**ORDER: AUTHORIZE SHERIFF'S DEPARTMENT PCO #6 FOR CHANGES TO  
TOILET COMPARTMENT LIGHTING AND SENSORS AND SINK AND LAVATORY  
CHANGES**

RE: A New Sheriff's Department Building  
and Improvements at the Detention  
Center— Phase 2 (Rebid 2)  
Lafayette County Board of Supervisors  
**PCO #6 – Toilet Compartment Lighting & Sensors; Sink & Lavatory Changes**

## PROFESSIONAL'S REQUEST FOR PRICING

**RFP NO. 3**

## L-2 UNDERCOUNTER SINK

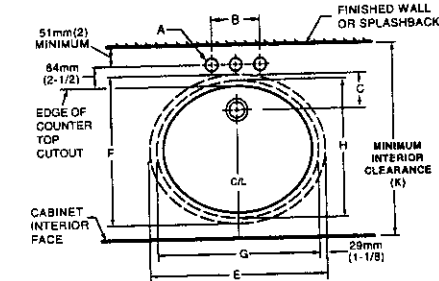
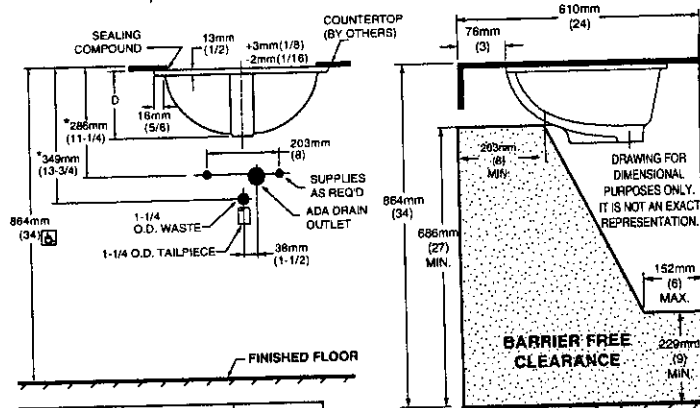
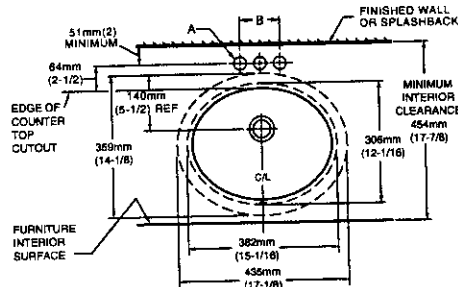
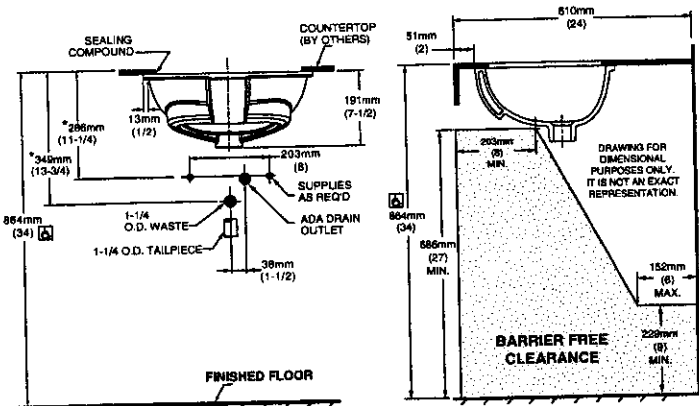
There would be no charge for Tri Star to change the L-2 lavatories, and the S-1&2 sinks to undermount sinks, if the countertop guy's mount the sinks, lavatories and drill the holes for the faucets. If this is to be done, we will need to know before the fixtures ship, which will be in September.

Item No. 2 — Change all 'L-2' lavatories, 'S-1' sinks, and 'S-2' sink from drop-in to undermounted types indicated on attached cut sheets. Provide all necessary fittings, installation hardware, etc. required for complete installation.

**1.1 LIGHTING PLAN - GROUND FLOOR**  
Scale: 1/8" = 1'-0"

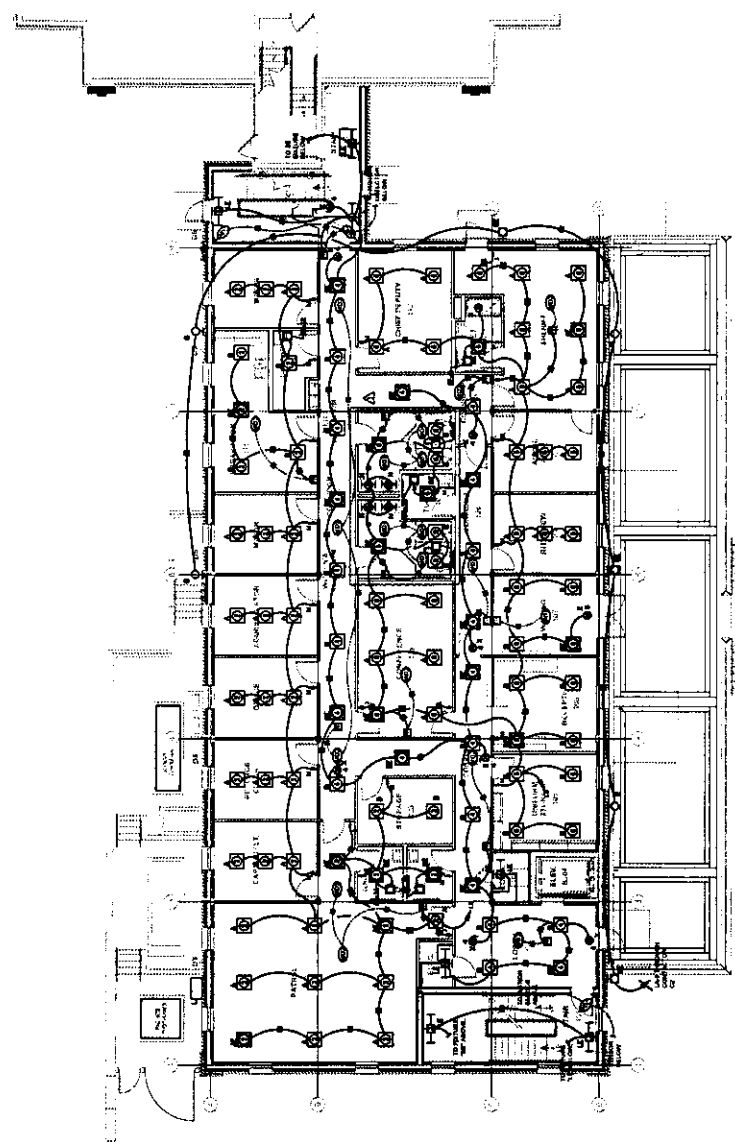
Item No. 1 — Add Type 'B' fixtures, Type 'M' fixtures, Type 'N' fixtures, and occupancy sensors in Women's Restroom 128, Men's Restroom 129, Men's Restroom 218 and Women's Restroom 219 per revised Lighting Plans on attached Sheets E1.1 and E1.2, and on revised Light Fixture Schedule on attached Sheet E0.0. Ceiling grids, existing Type 'B' & 'BE' fixtures, HVAC supply air diffusers, and exhaust grilles have been reconfigured to accommodate layouts of privacy-type toilet compartments. Install per revised RCP's on attached Sheets A1.2 and A1.3.
